SAN FRANCISCO PLANNING DEPARTMENT

Addendum to Mitigated Negative Declaration

Date of Publication of the Addendum: March 17, 2017
Date of Final MND: May 2, 2016
Case No.: 2013.1761E
Project Title: **PG&E Gas Transmission Line 109 Cañada Road,
Bunker Hill, and Crystal Springs Pipeline
Replacement Project San Mateo County**
Zoning: Resource Management
Block/Lot: Various
Project Sponsor: Pacific Gas and Electric Company (PG&E)
Kristina Caliendo
Lead Agency: San Francisco Planning Department
Staff Contact: Paul Maltzer – (415) 575-9038
paul.maltzer@sfgov.org

Figure 3
Project Overview Map
Crystal Springs Segment

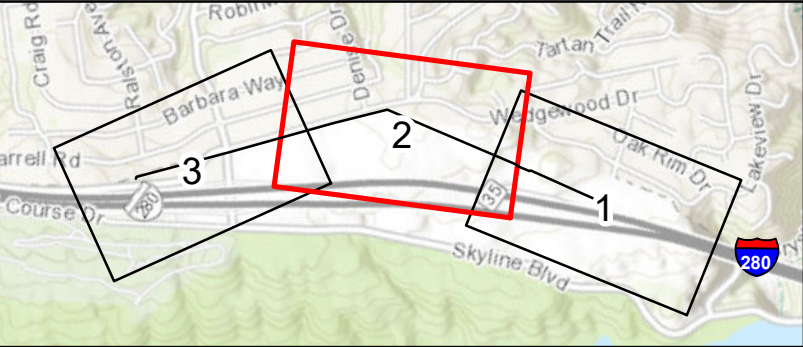
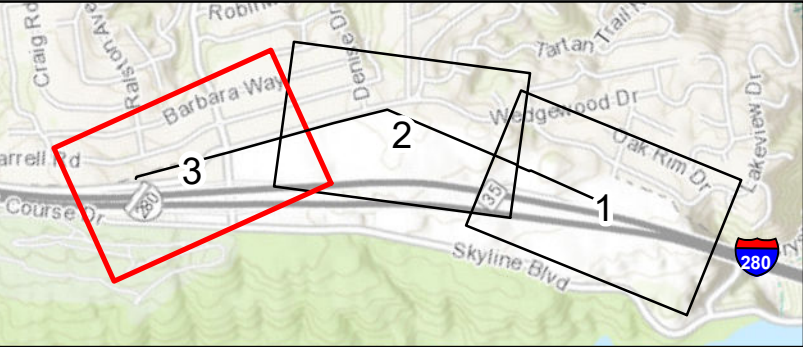
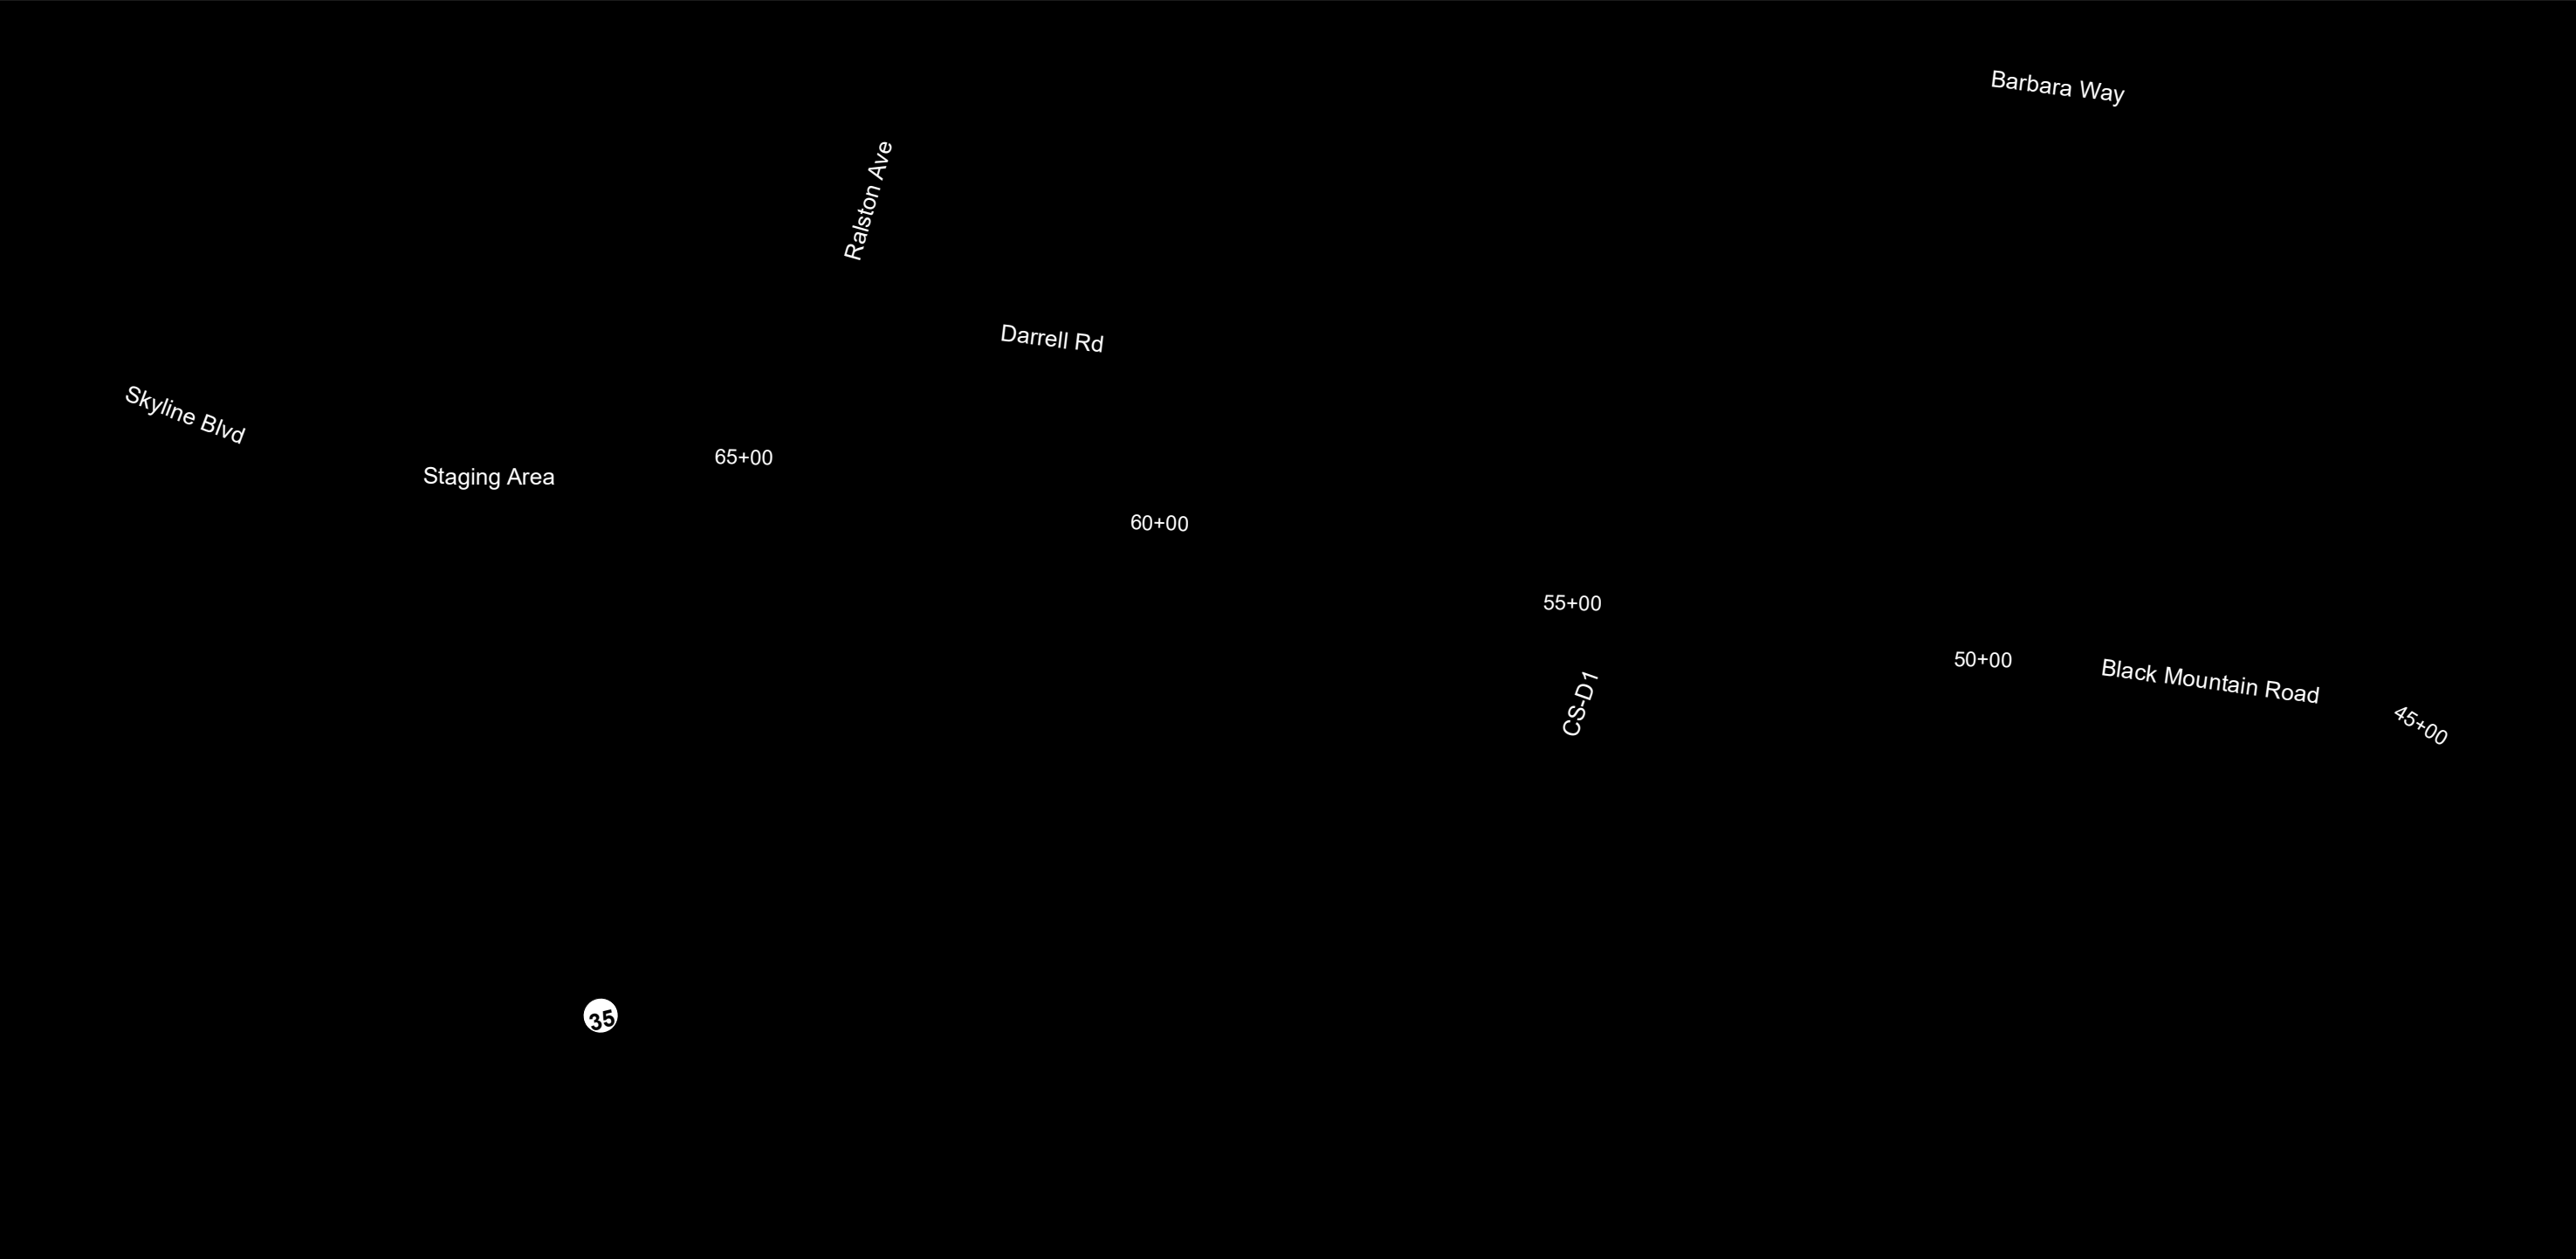
- The 1.2-mile-long Crystal Springs segment replacement would be changed to a parallel offset alignment, rather than being replaced in-place. The new offset alignment would be 5 to 7 feet from the existing pipeline. The existing L109 pipeline would be abandoned in place and filled with concrete slurry after construction of the replacement pipeline.
- New permanent pipeline easement is requested by PG&E for the new alignment.

Figure 3 : Project Overview Map Crystal Springs Segment, in Appendix A in the Final MND represents the original Crystal Springs segment alignment; revised Figure 3 in this Addendum shows the proposed, modified Crystal Springs segment alignment.

With this change, the same approximately 1.2-mile-long segment of L109 would be replaced with 24- and 30-inch pipeline, except that a new trench would be excavated parallel to the existing alignment for installation of the new pipeline. The offset alignment would follow the same route and tie-in to the existing L109 at the same locations as the replace-in-place alignment would have.

The same temporary work space, construction staging, ground disturbance, and access points covered in the MND and the License are sufficient for construction of the proposed offset alignment. PG&E proposes the acquisition of new permanent pipeline easement, approximately 3.7 acres, for the 4C offset alignment (modified project), shifted approximately 5 to 7 feet from the alignment previously approved, as shown in revised Figure 3. The original project analyzed in the MND did not include the acquisition of new permanent pipeline easement for the Crystal Springs segment.
